Project: PRA-ROCR 10(5)
The purpose of this Amendment is to:

Amendment No. 0002
Project PRA-ROCR 10(5)
Rock Creek Park
Solicitation: DTFH71-16-R-00001

Project Name: Beach Drive from Rock Creek Parkway to Maryland State Line

AMENDMENT NO. 2 ◇1	PMIS NO.	NPS NO.	STATE	PROJECT	SHEET NO.
	044965	821 / 100425	DC	PRA-ROCR 10(5)	D29

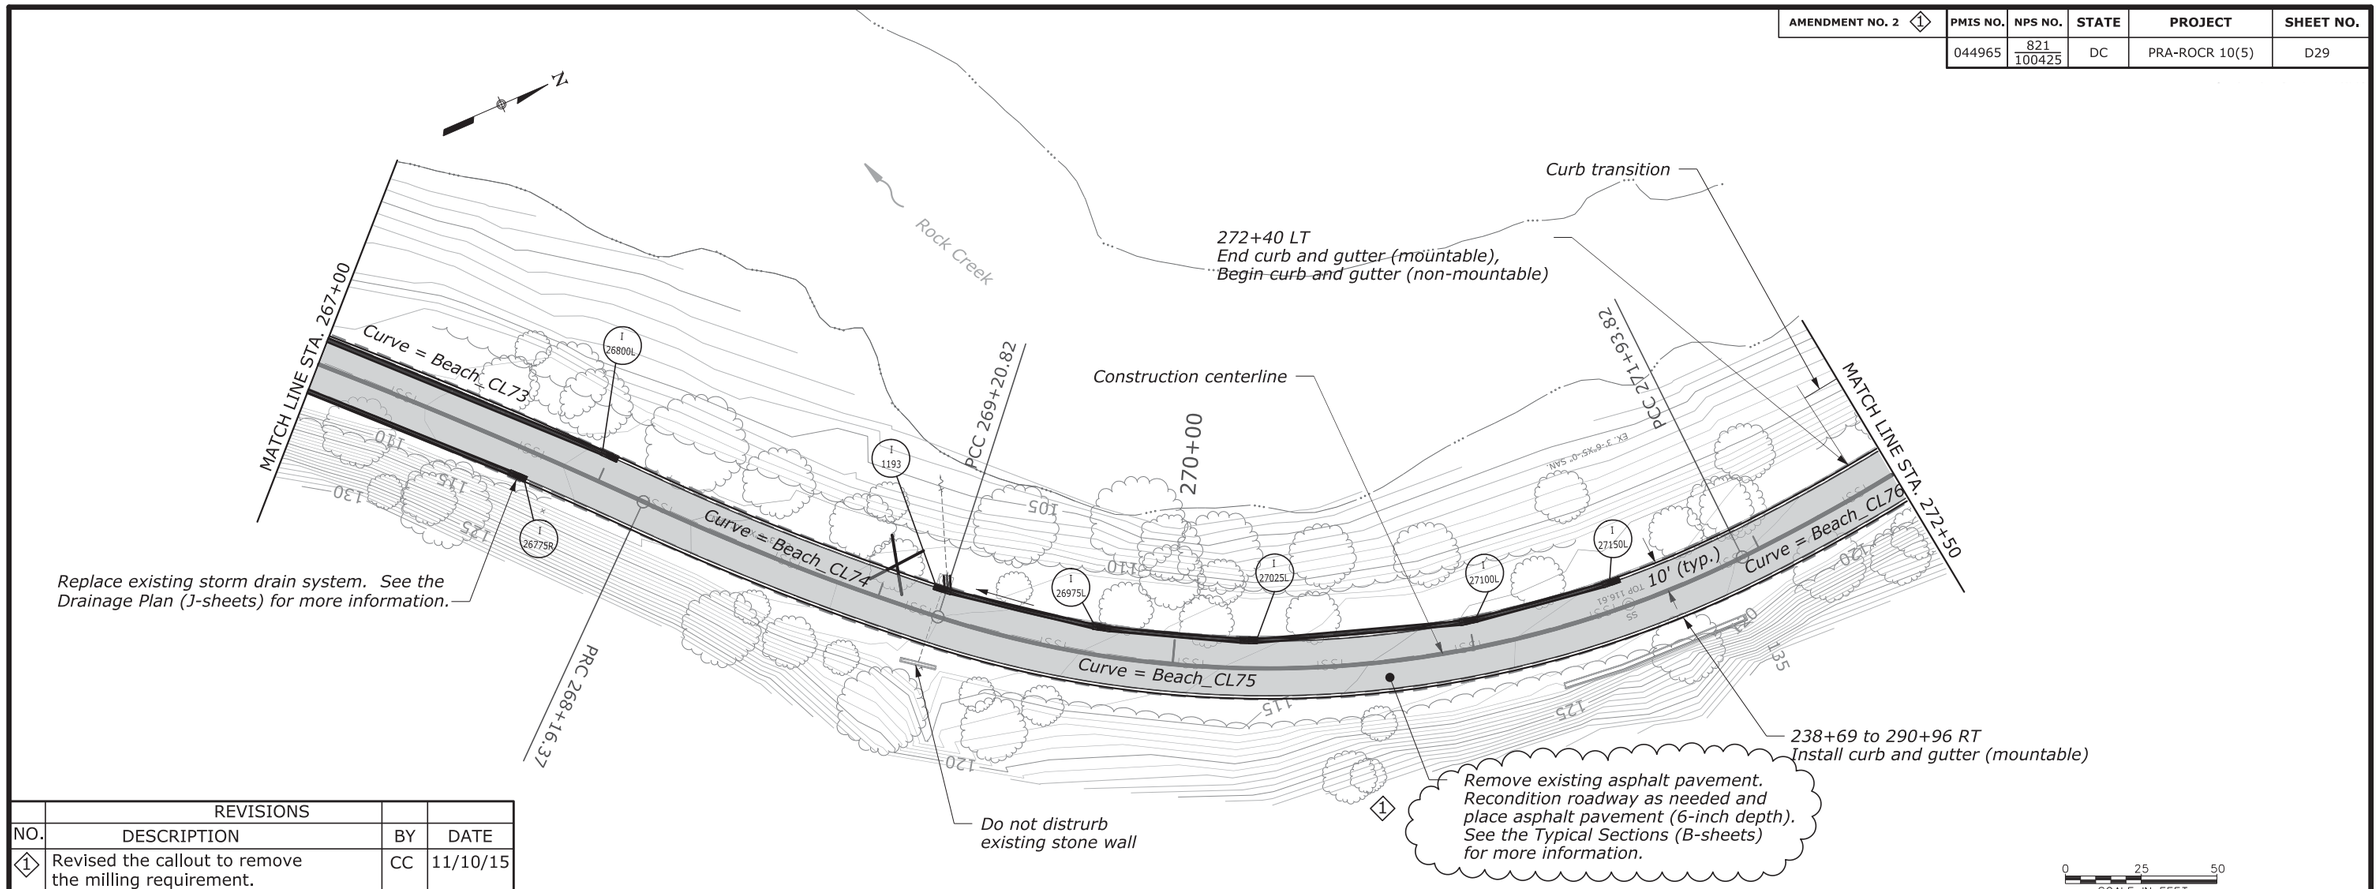
REVISIONS			
NO.	DESCRIPTION	BY	DATE
◇1	Revised the callout to remove the milling requirement.	CC	11/10/15

AMENDMENT NO. 2 ①	PMIS NO.	NPS NO.	STATE	PROJECT	SHEET NO.
	044965	821 / 100425	DC	PRA-ROCR 10(5)	D30

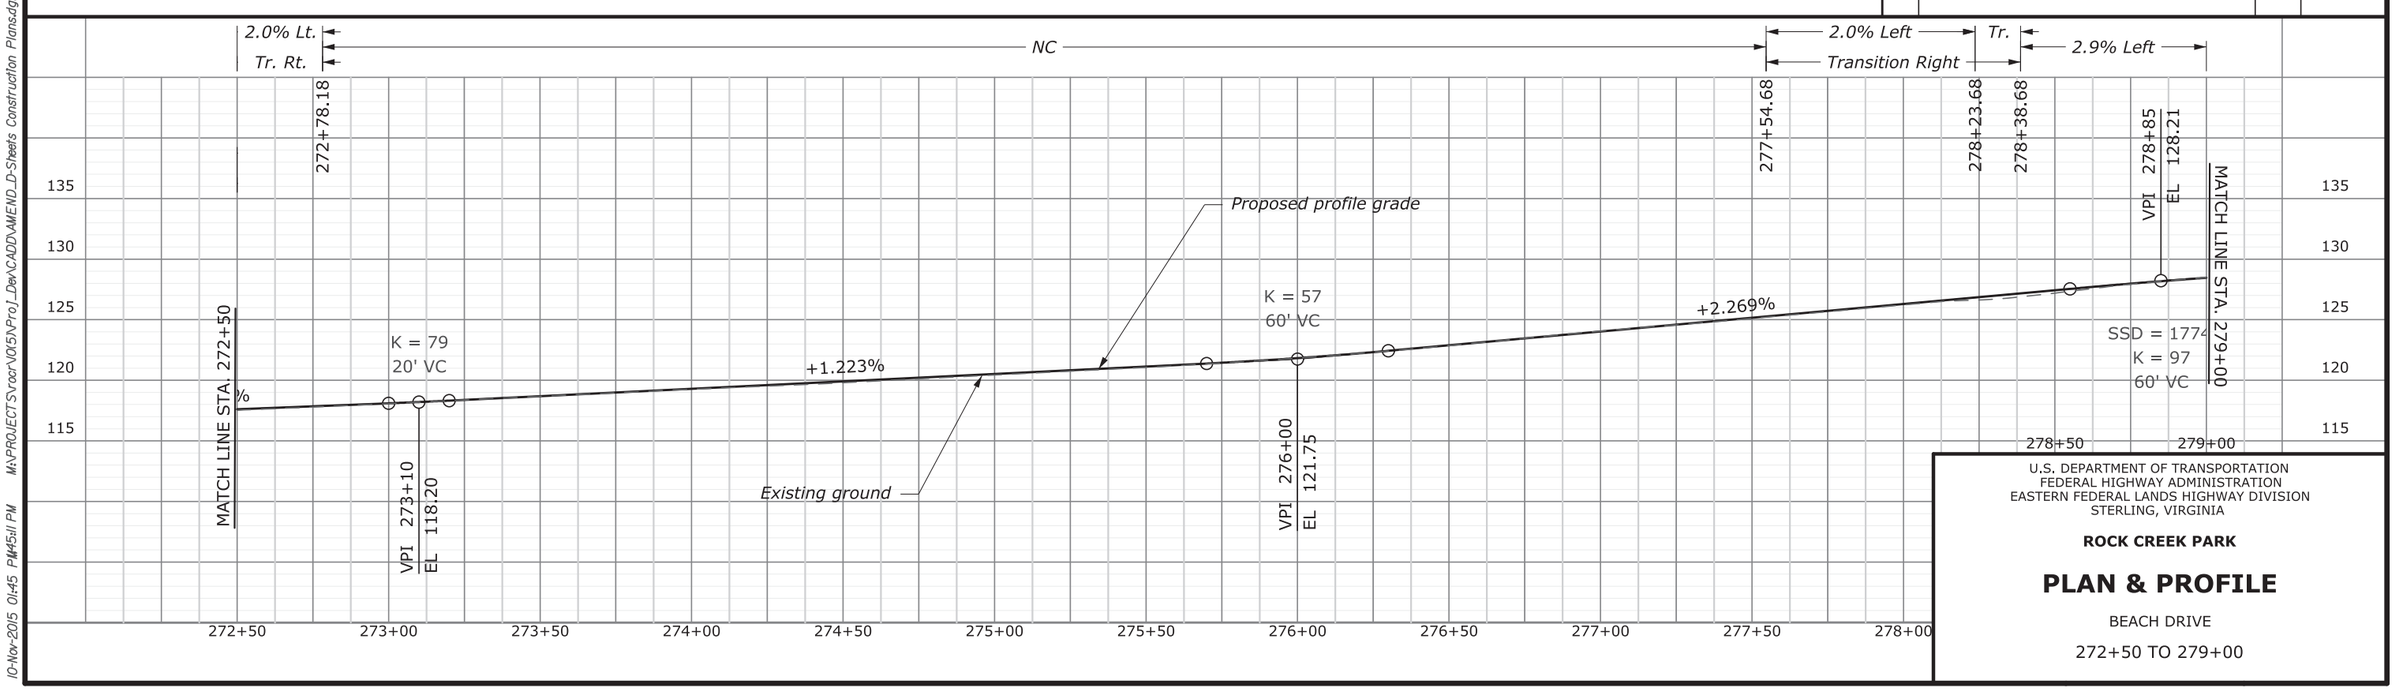
REVISIONS			
NO.	DESCRIPTION	BY	DATE
①	Revised the callout to remove the milling requirement.	CC	11/10/15

AMENDMENT NO. 2 ◇1	PMIS NO.	NPS NO.	STATE	PROJECT	SHEET NO.
	044965	821 / 100425	DC	PRA-ROCR 10(5)	D31

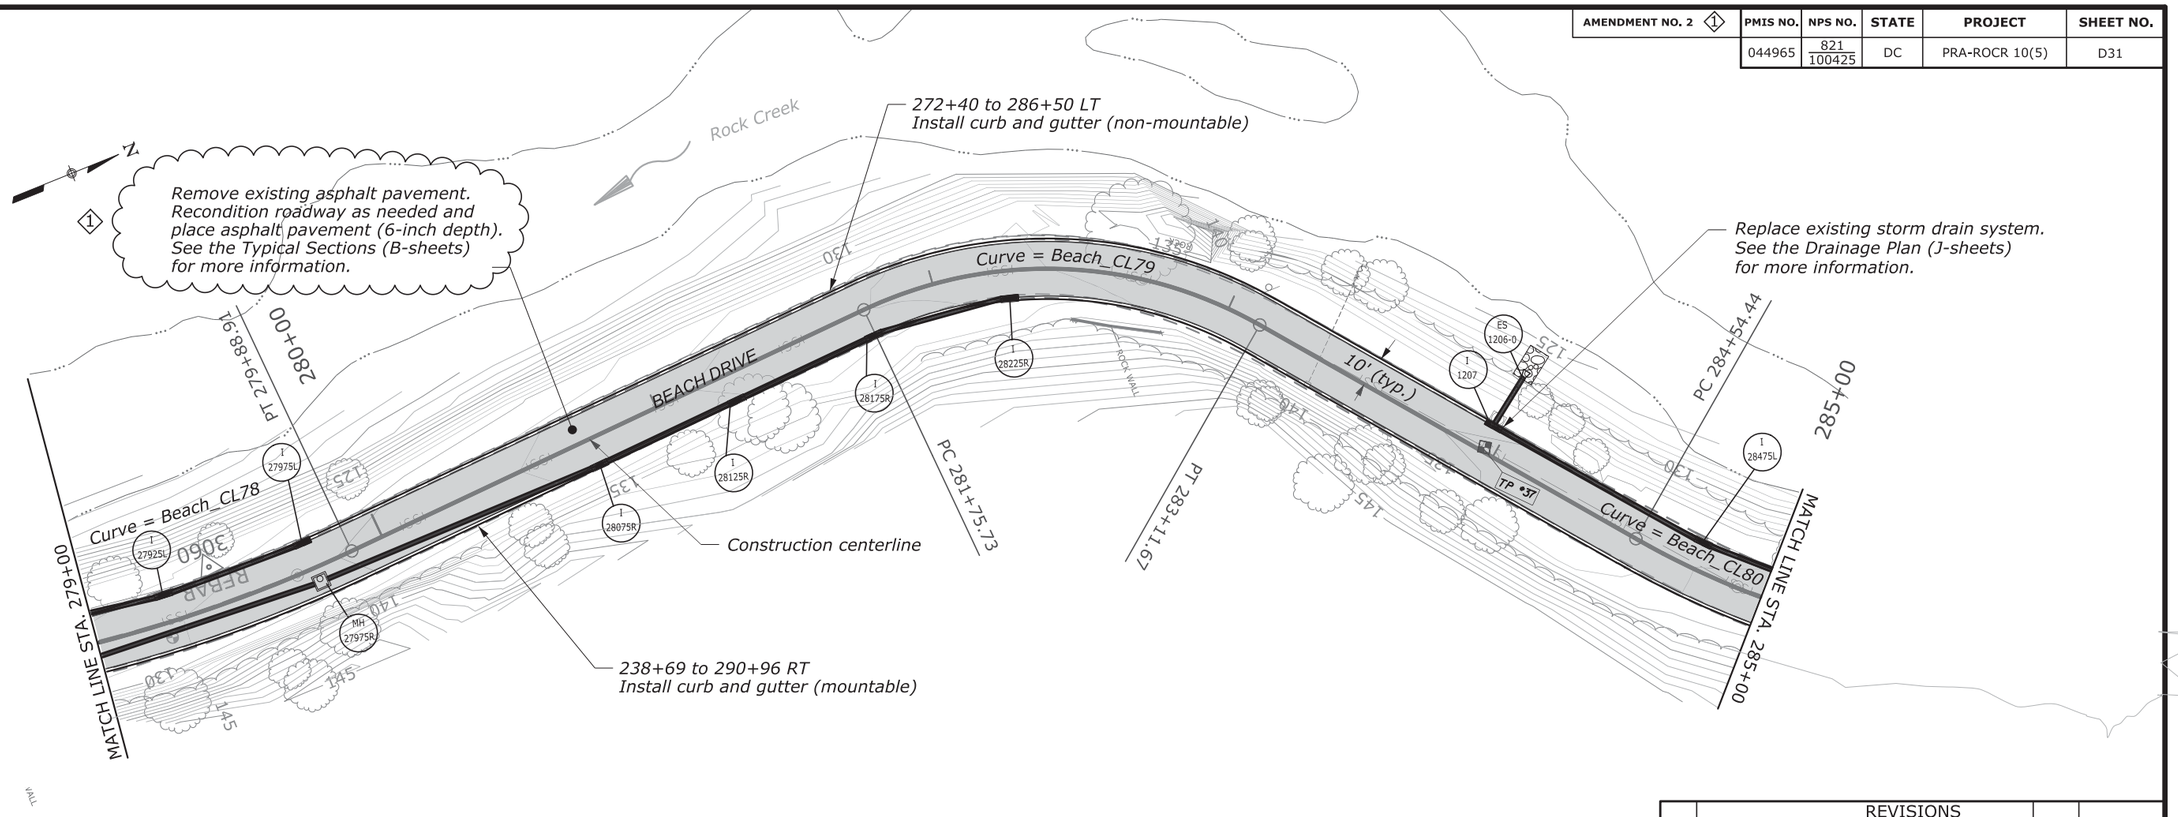
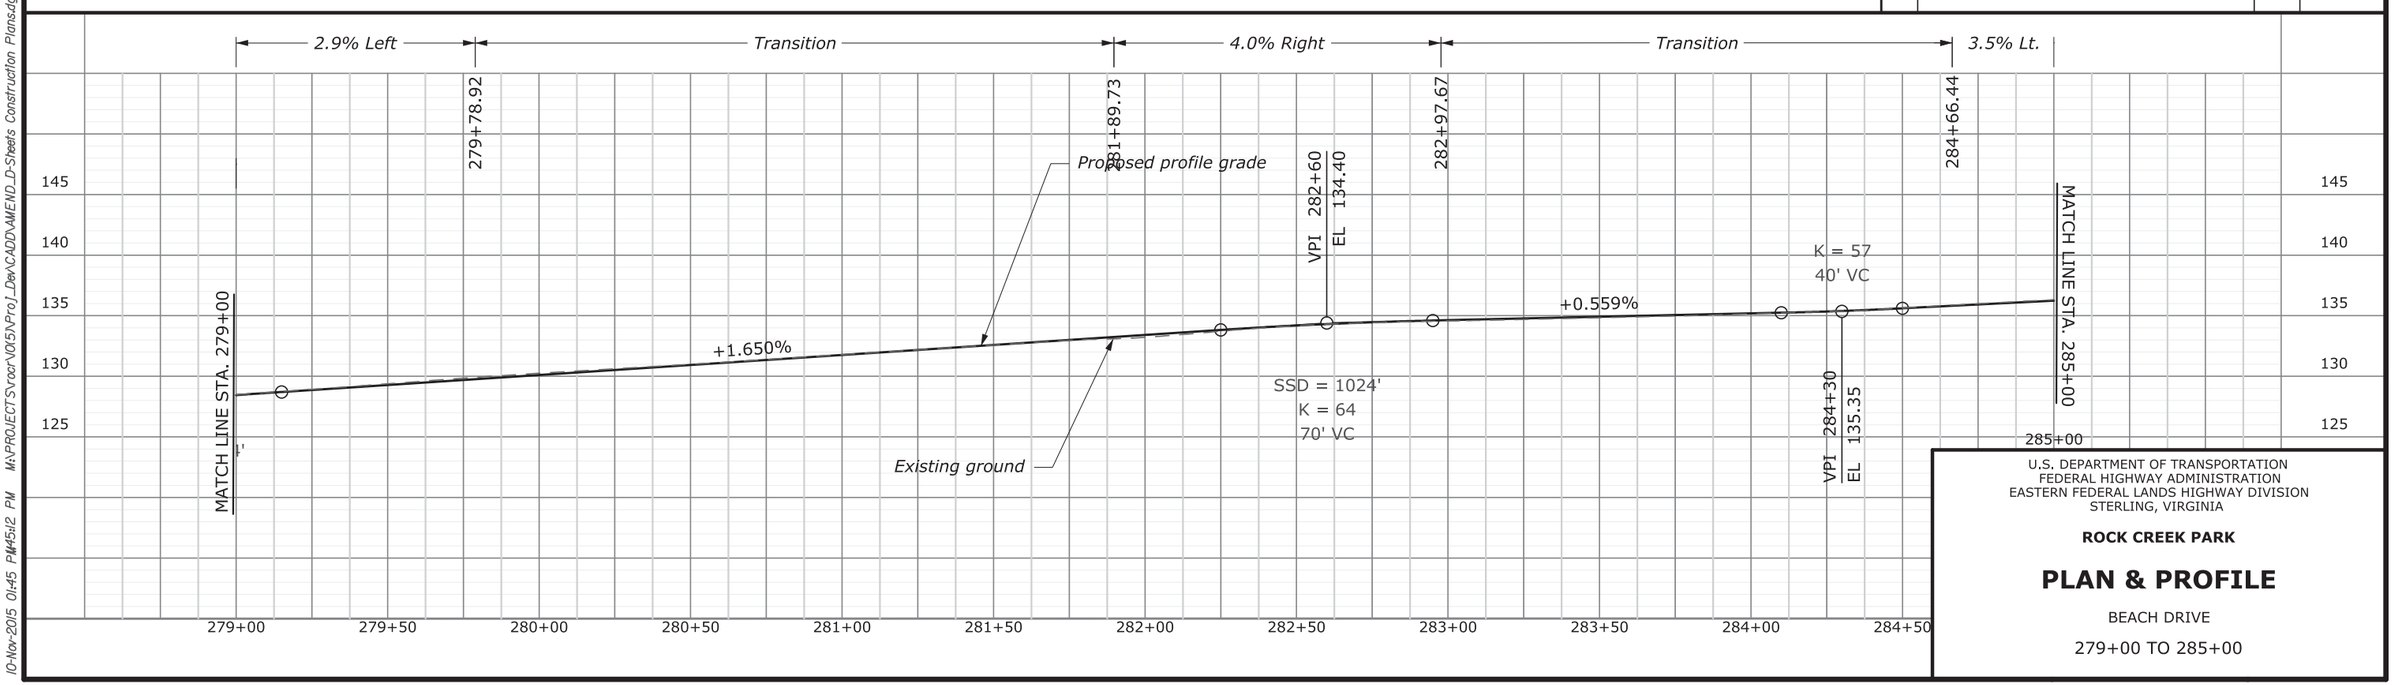
NO.	REVISIONS DESCRIPTION	BY	DATE
◇1	Revised the callout to remove the milling requirement.	CC	11/10/15

AMENDMENT NO. 2 ①	PMIS NO.	NPS NO.	STATE	PROJECT	SHEET NO.
	044965	821 / 100425	DC	PRA-ROCR 10(5)	D32

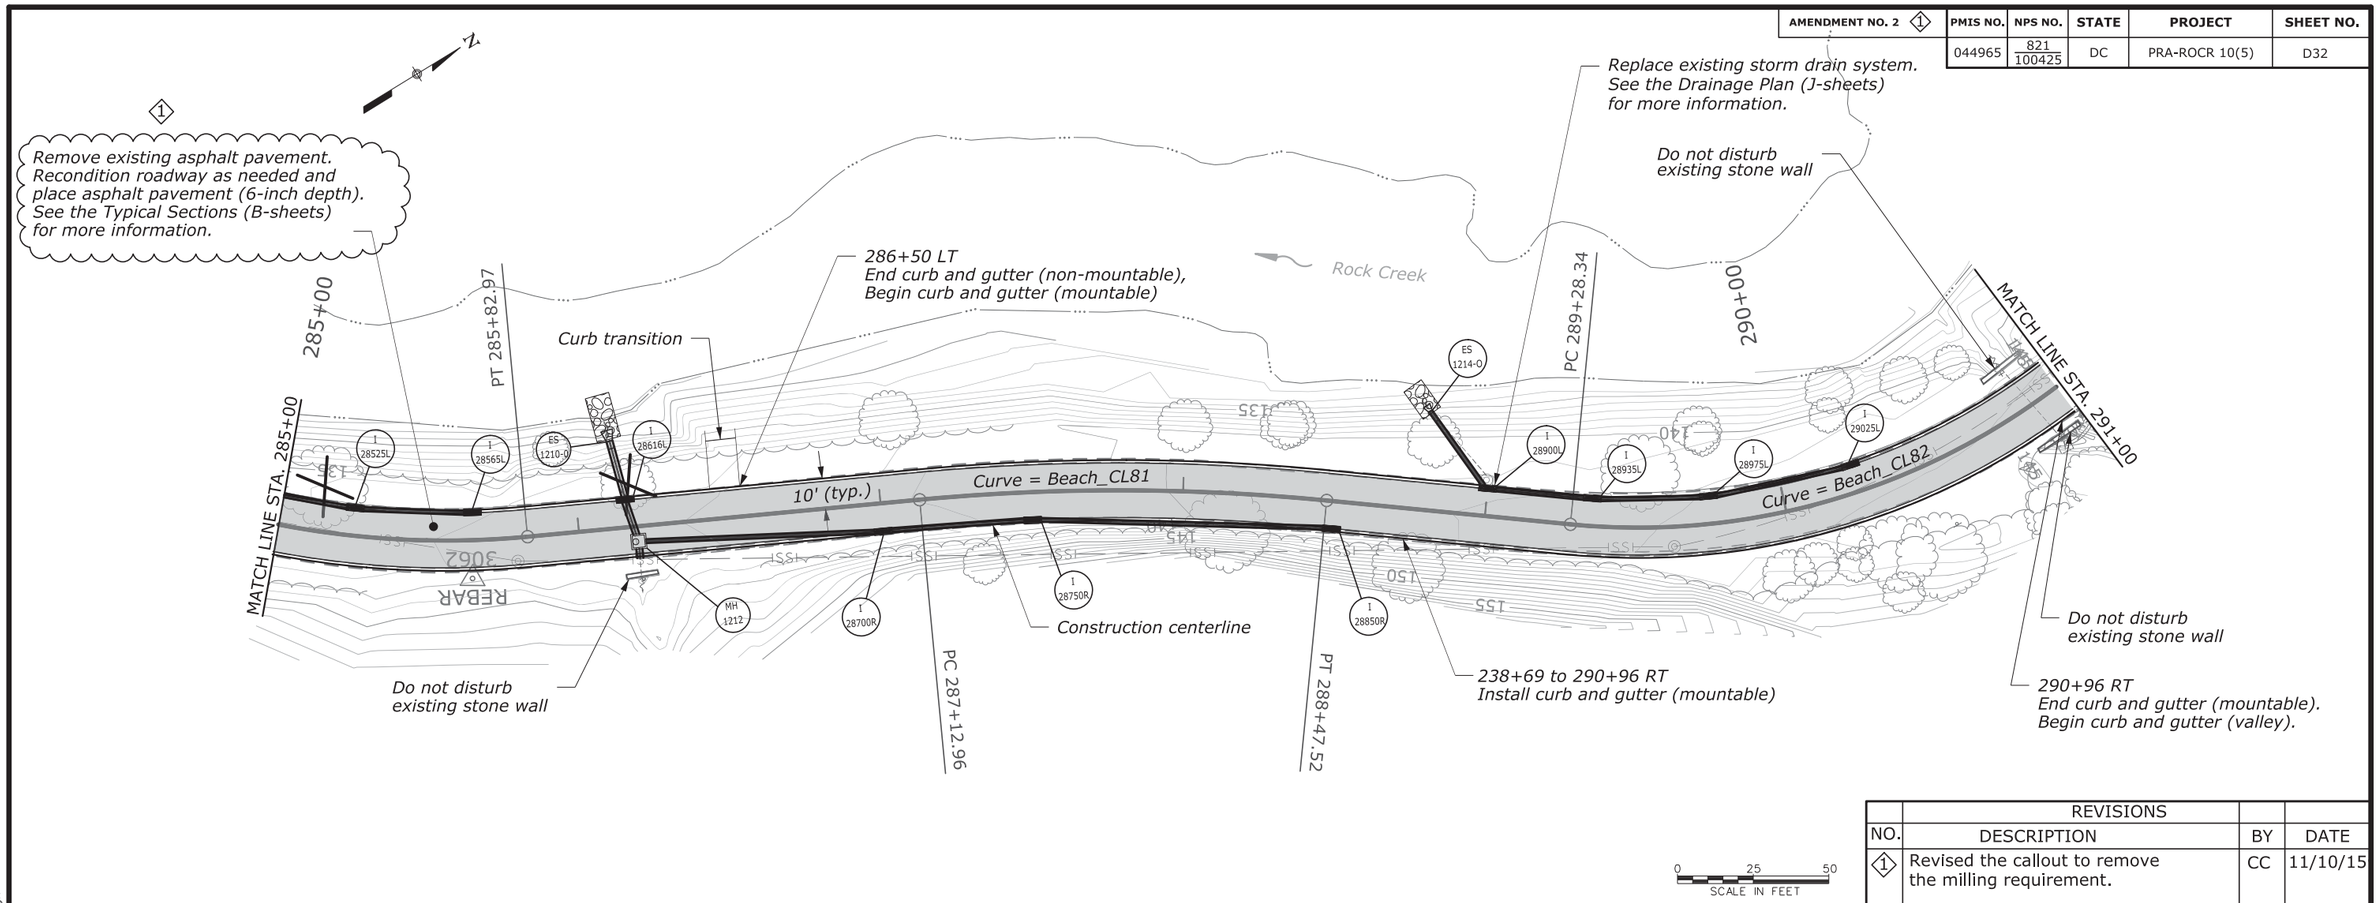
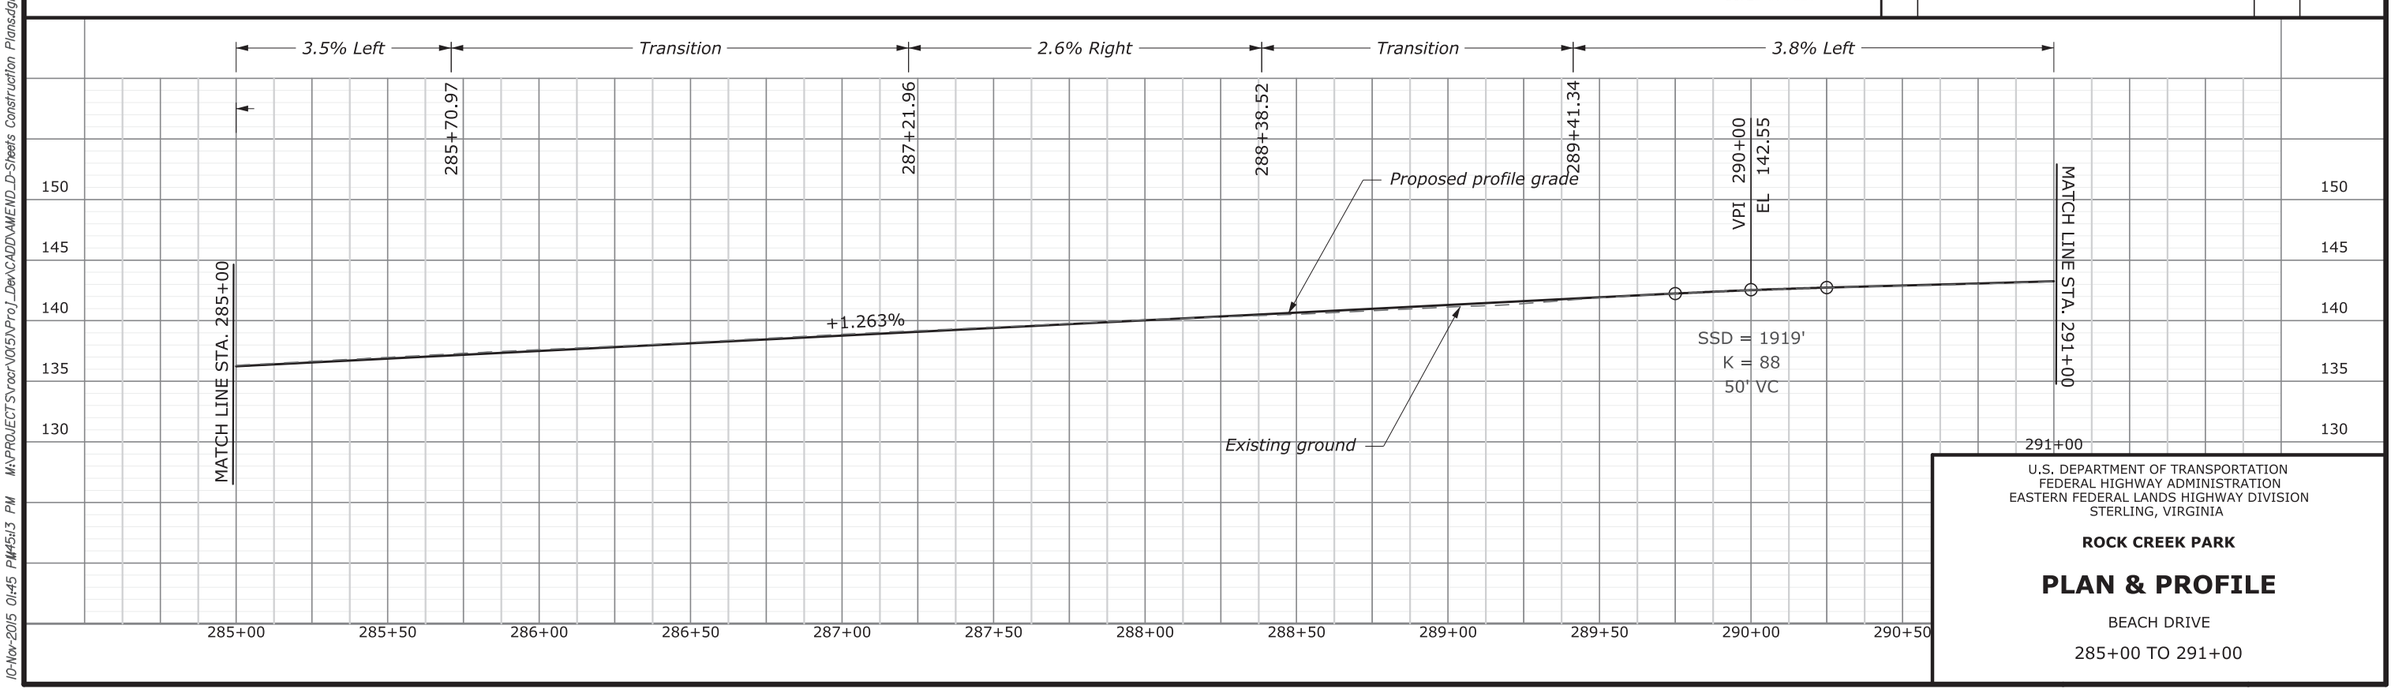
REVISIONS			
NO.	DESCRIPTION	BY	DATE
①	Revised the callout to remove the milling requirement.	CC	11/10/15
